MONITORING YEAR 6 ANNUAL REPORT

HOGAN CREEK STREAM MITIGATION PROJECT

RE: Hogan Creek Stream Mitigation Project
Yadkin River Basin – CU# 03040101
Surry County, North Carolina
NCEEP Project # 94708
Contract No. 6496

Wildlands Engineering, Inc. (Wildlands) has reviewed the Division of Mitigation Services (DMS) comments from the Draft Monitoring Year 6 report for the Hogan Creek Stream Mitigation Project. The following Wildlands responses to DMS's report comments are noted in italics lettering.

Figures 3.0-3.3 Current Condition Plan View Maps

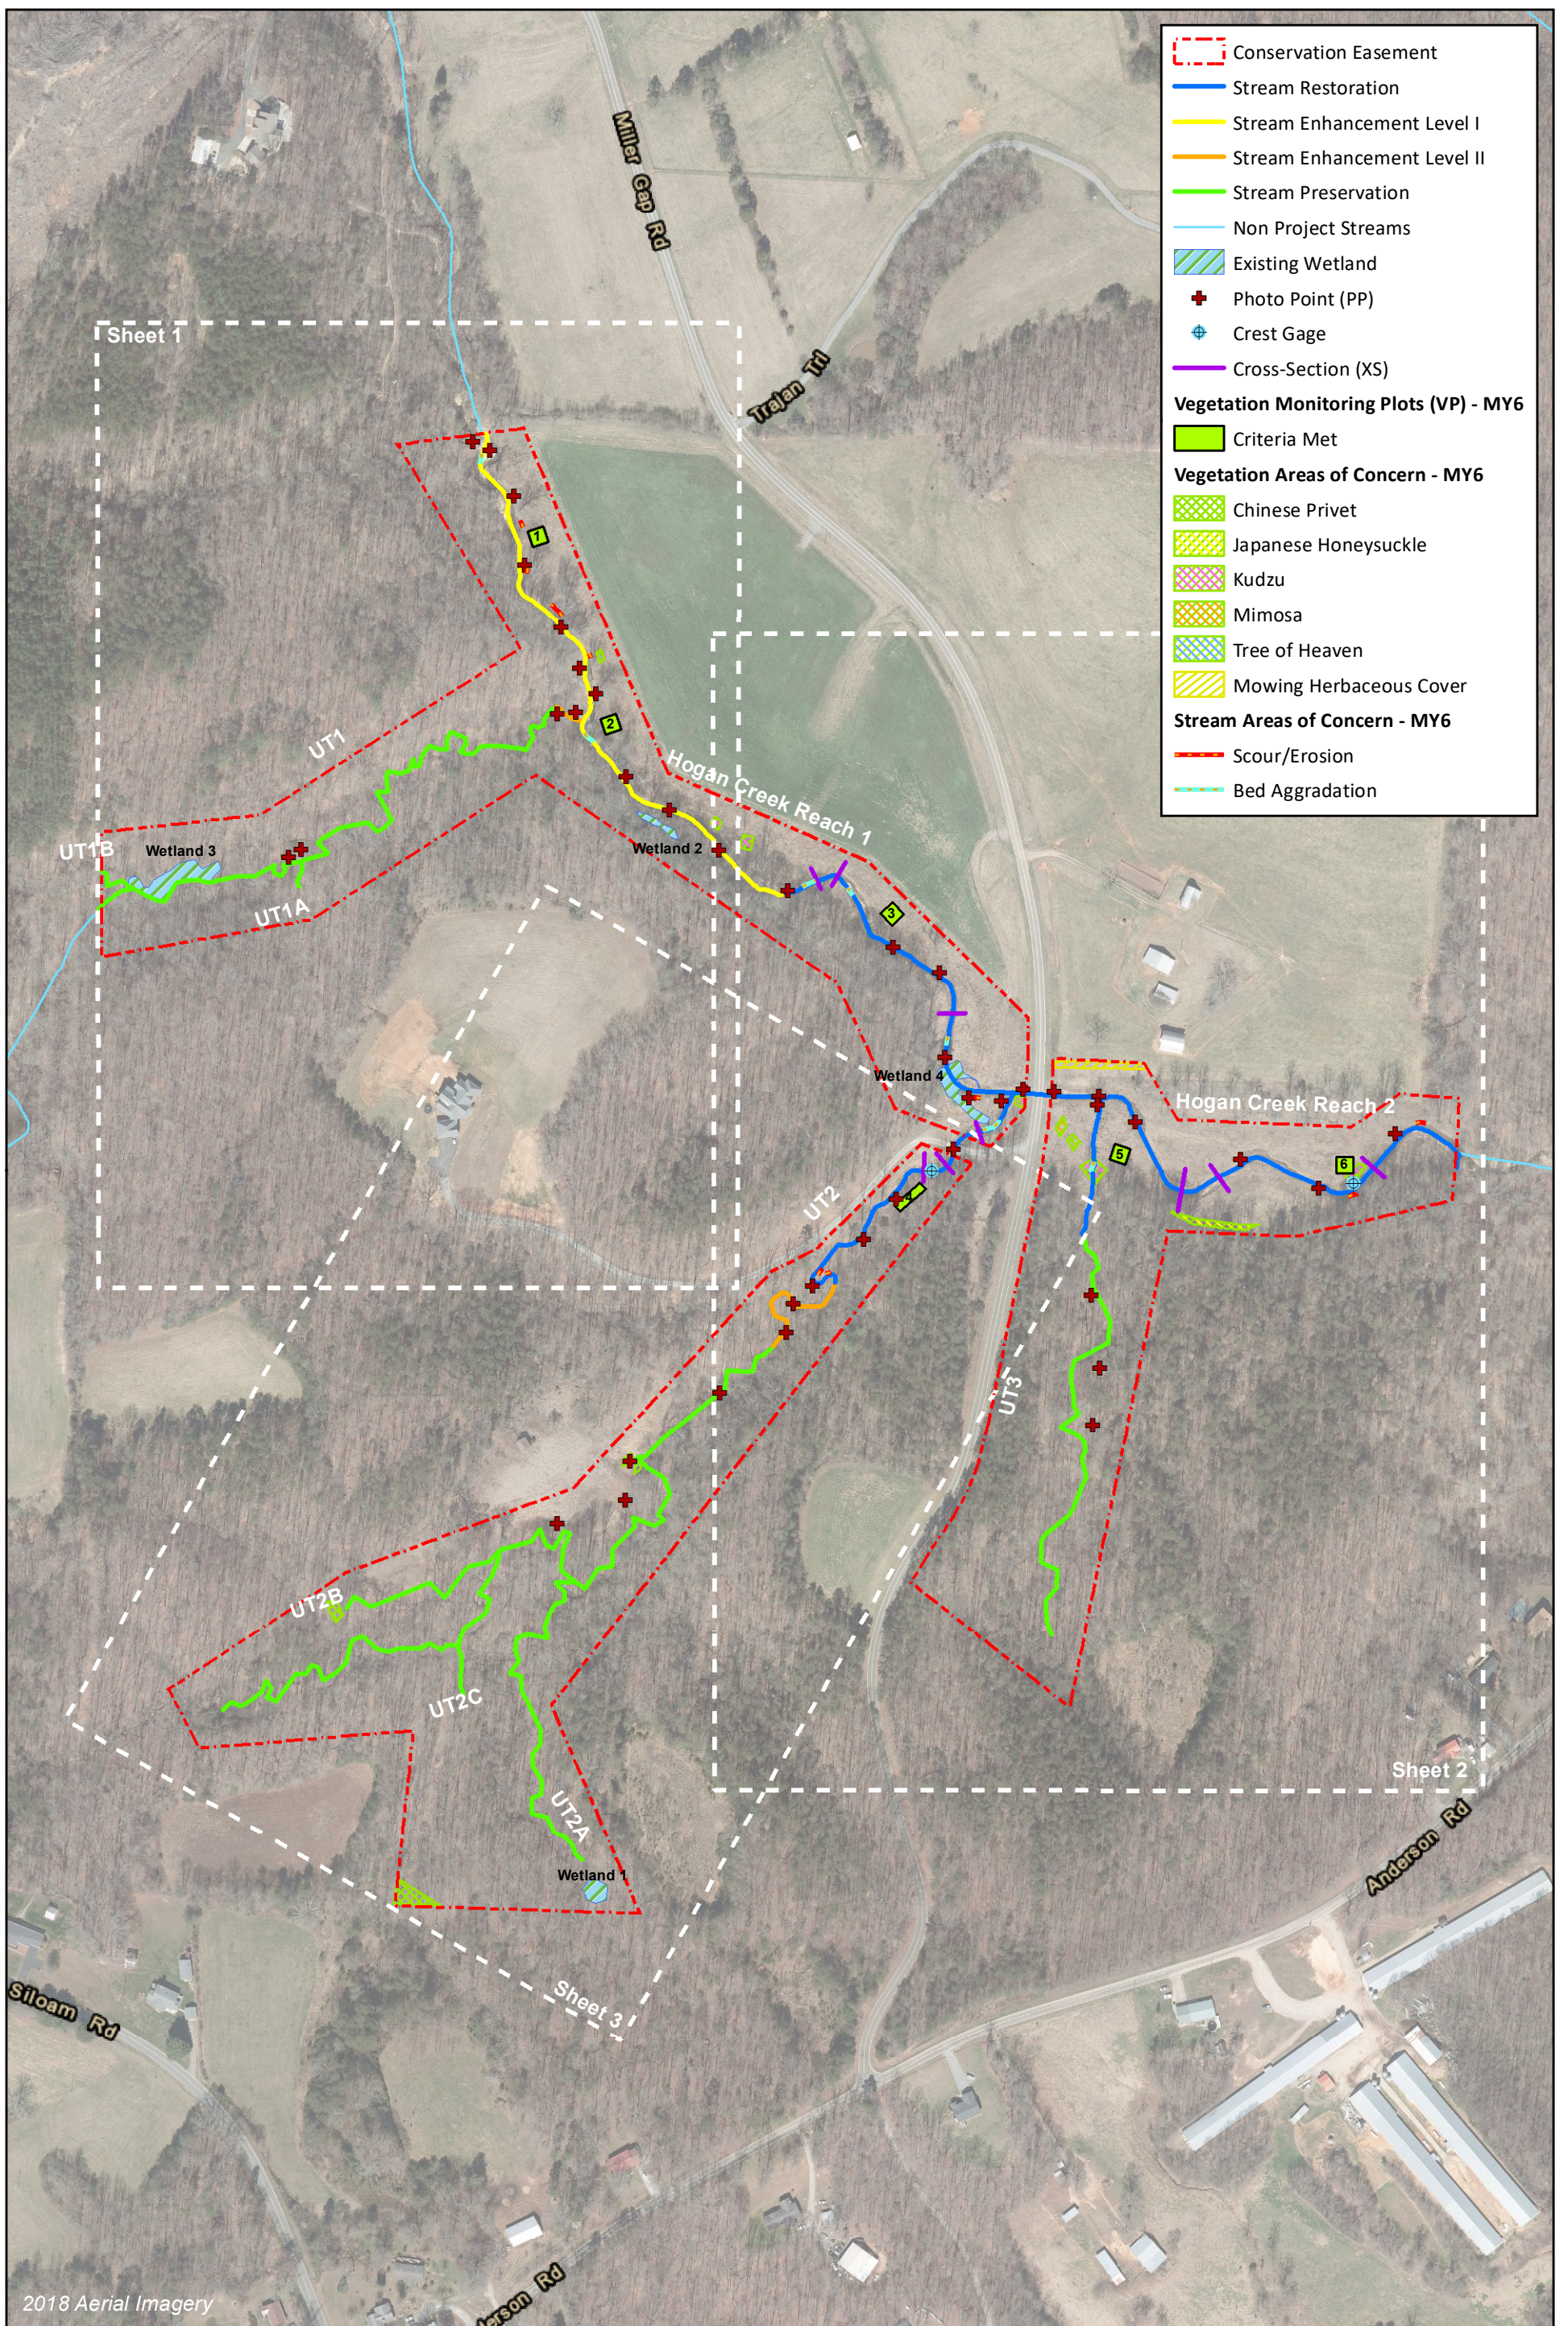
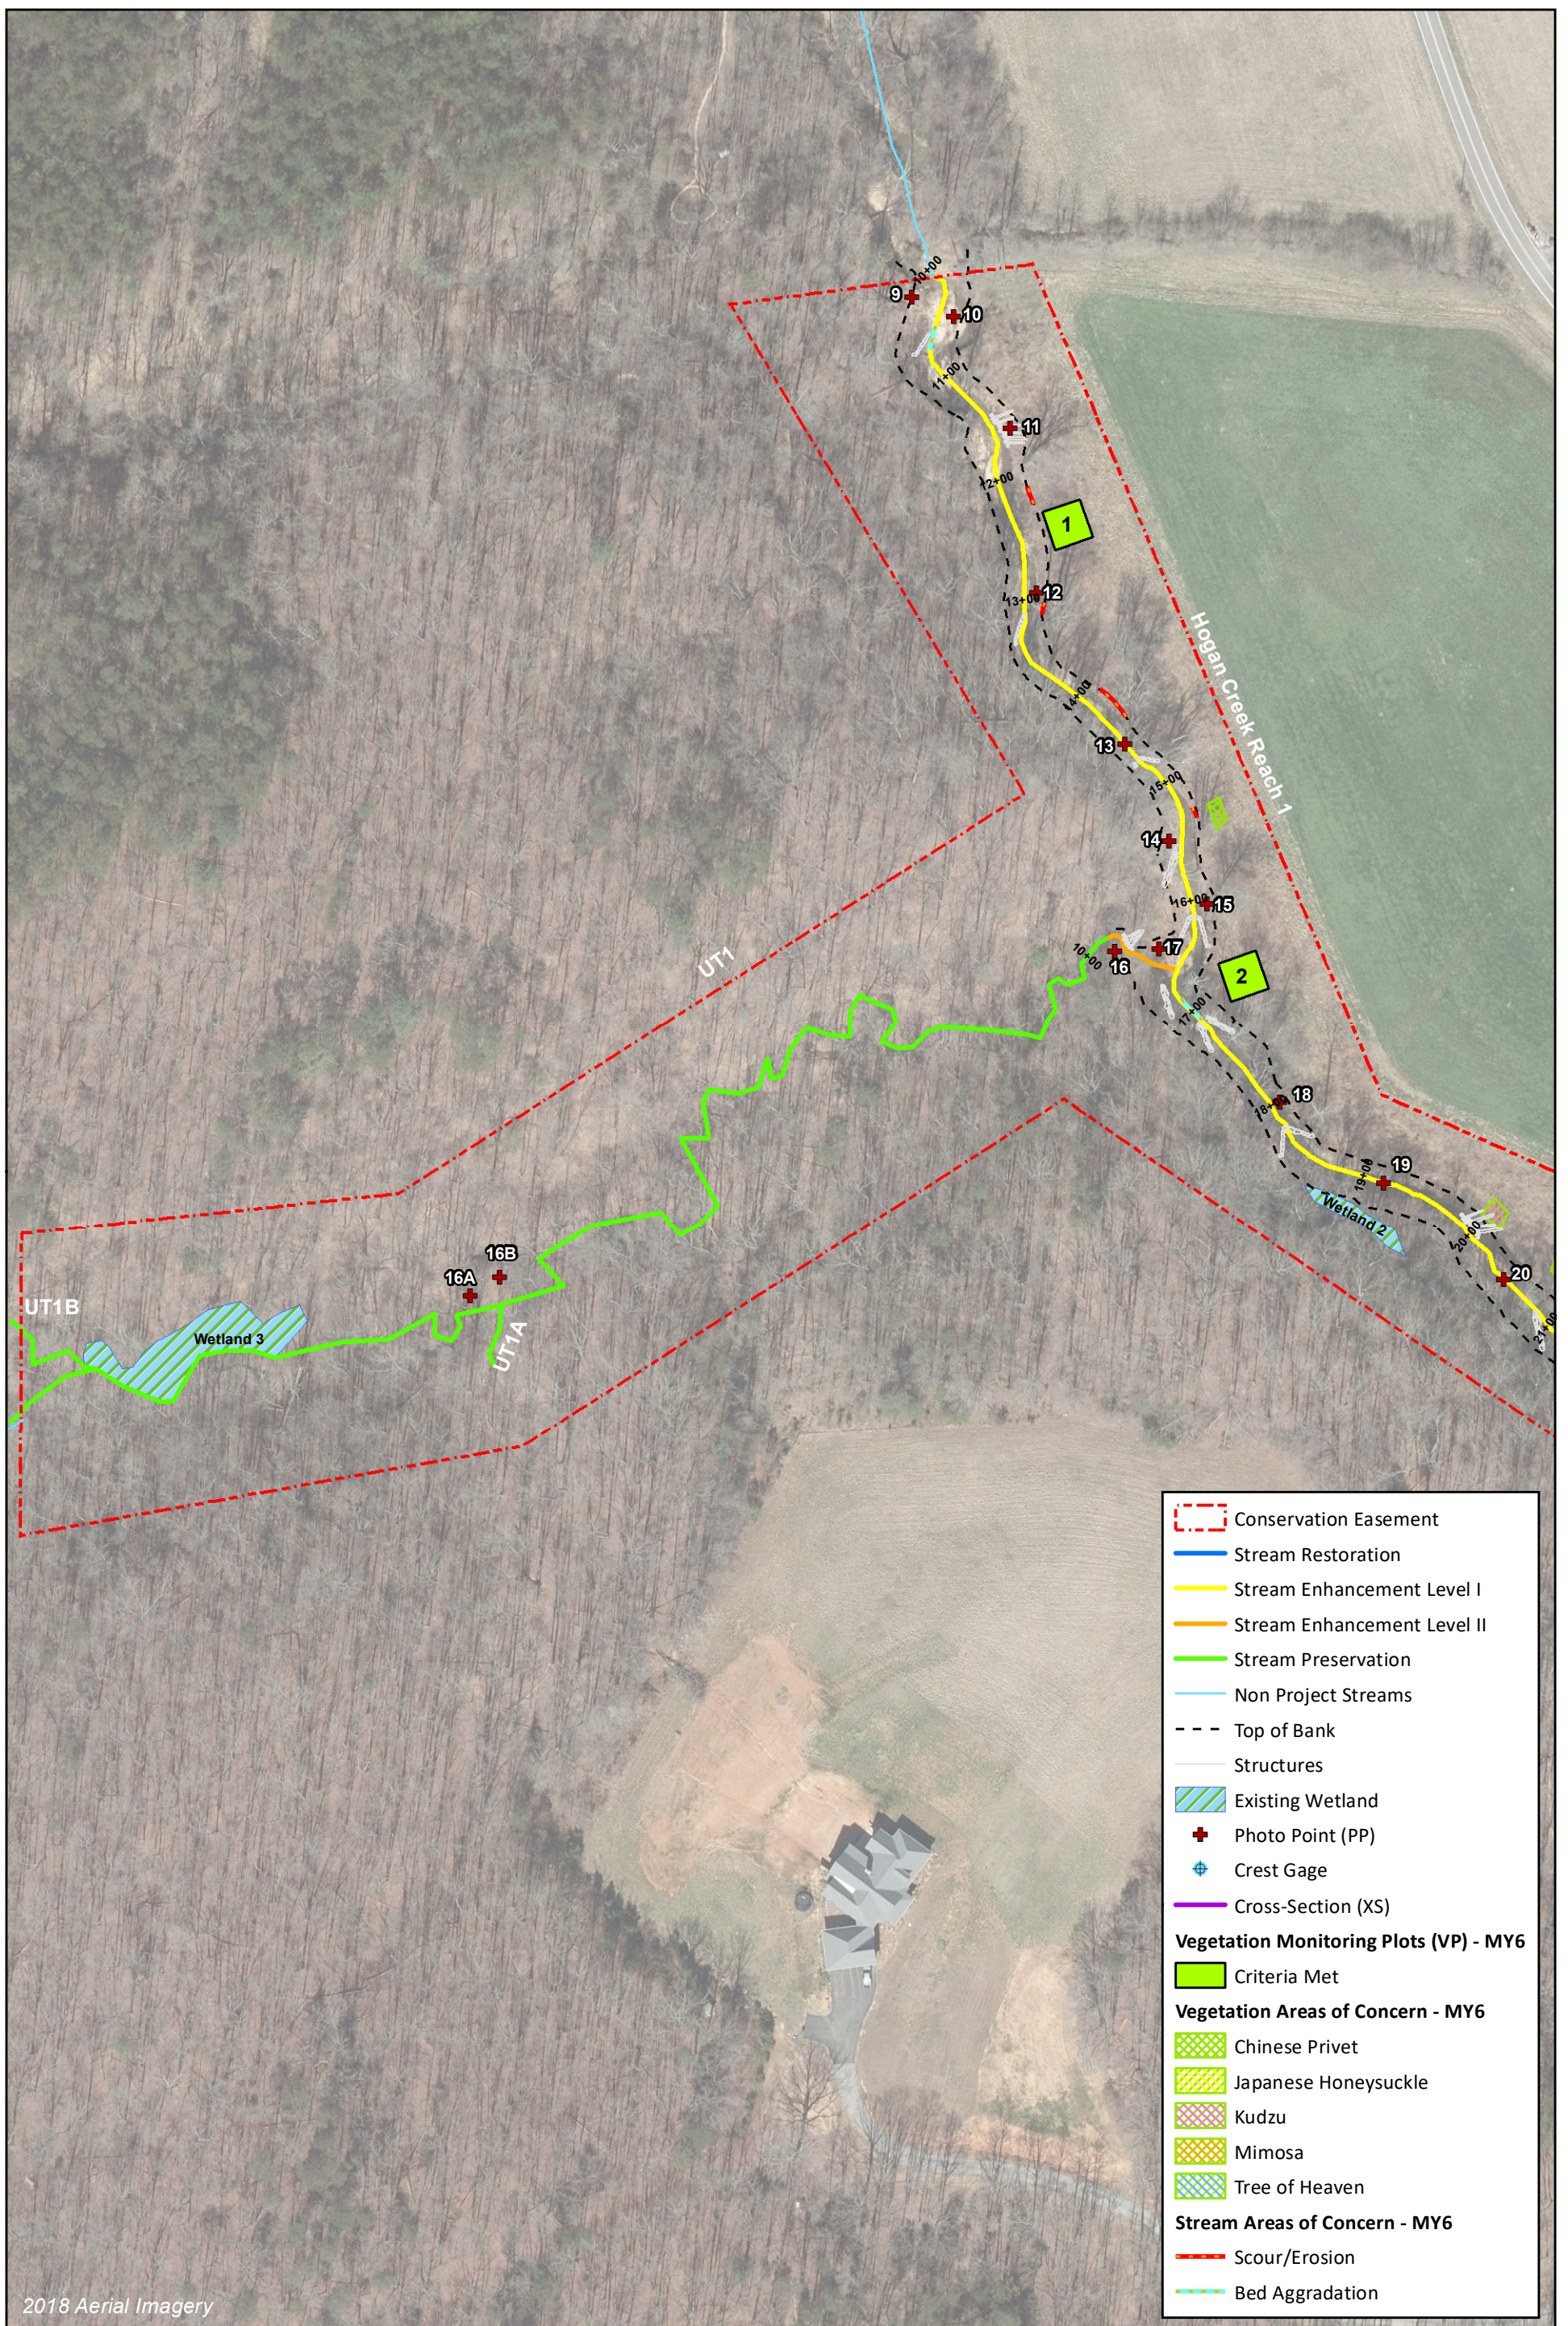
DMS comment; Thank you for updating the CCPV to reflect the invasive treatment that has occurred on the site. DMS will continue to have the invasives treated through December 2021.

Wildlands response; Text in Section 1.2.2 has been updated to specify that invasive treatments will continue through December 2021.

DMS comment; Table 6b and 6c: There are two structures marked as unstable under the “Overall Integrity” category, but they are not shown on the CCPV or discussed in the stream problem area of the report. Can you please verify if these are still problems or if they have healed over time? Please add a call out or mark the location of the structures on the CCPV if they are a problem or remove from the table.

Wildlands response; Two rootwad structures, one along Hogan Creek Reach 2 near station 37+30 and the other along UT2 near station 9+50, were noted to have some bank scour at these locations which is shown on the CCPV. However, upon additional consideration, the overall integrity of these structures has not been compromised since the bank scour is minor with woody vegetation still established along the bank. Tables 6b and 6c have been updated to account for this just in the Bank Protection channel sub-category.
